SERVICE BULLETIN

APPLICABILITY: 2019MY Impreza
2019MY Crosstrek

NUMBER: 07-156-19

SUBJECT: Multi-Function Display (MFD):
Black (Blank) Screen / Restarting During Start-Up

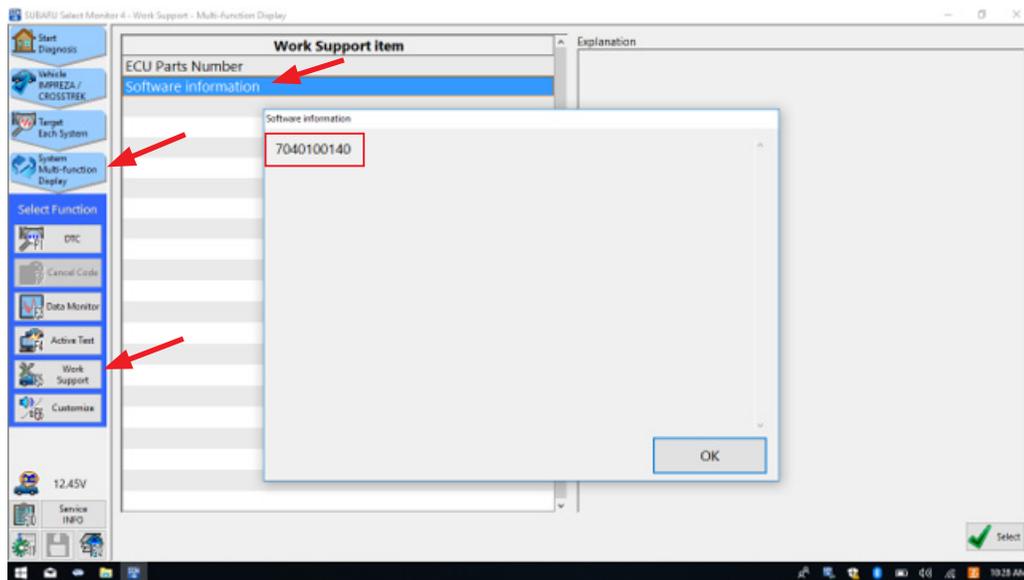
Step 2) Use the SSM4 to check the MFD software version following the screen selection sequence below:

Select: Each System > Multi-function Display > Work Support > Software information

- Software version **7040100130**, is the OLD version. Replace the MFD assembly.
- The NEW software version is **7040100140**.

Step 3) When necessary, the MFD replacement procedure remains unchanged. Always refer to the applicable Service Manual to review the full requirements of the repair being performed. The Service Manual procedures contain information critical to perform effective repairs the first time, every time.
